Seattle design Commission

APPROVED MINUTES OF THE MEETING

May 21, 2009

SOUTH PORTAL CONCEPT A

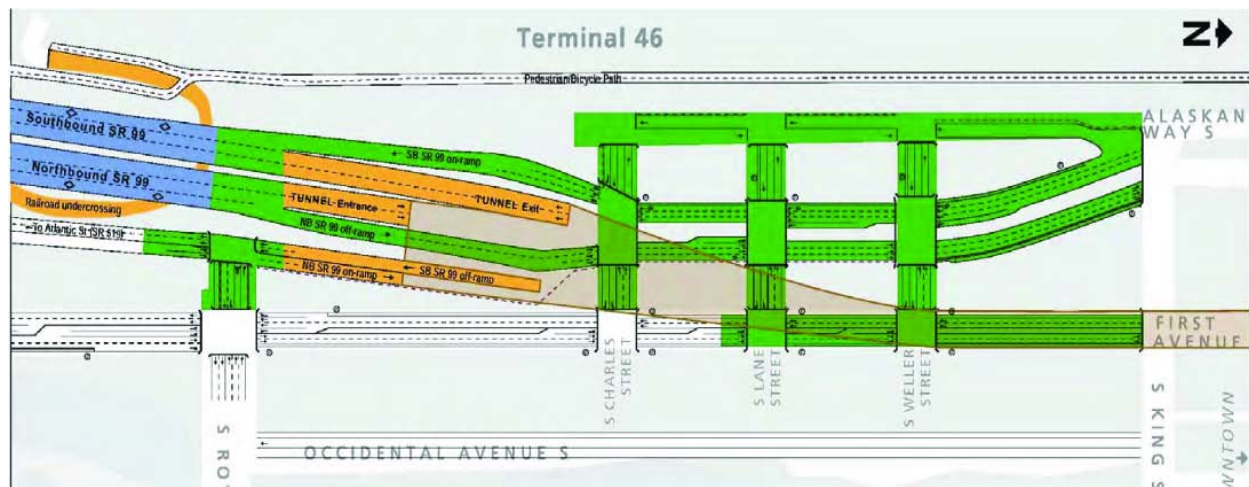
At the north portal, will developable land in blocks be created as at the south portal?

It's critical to have designers within the working group so that it is a factor in the design of the project from initial conception.

We are not disrupting the north as much as the south. In the south you have a large industrial site that will be redefined with the new street grid. There will be opportunities, but they will be subtler. It's more about connectivity up here.
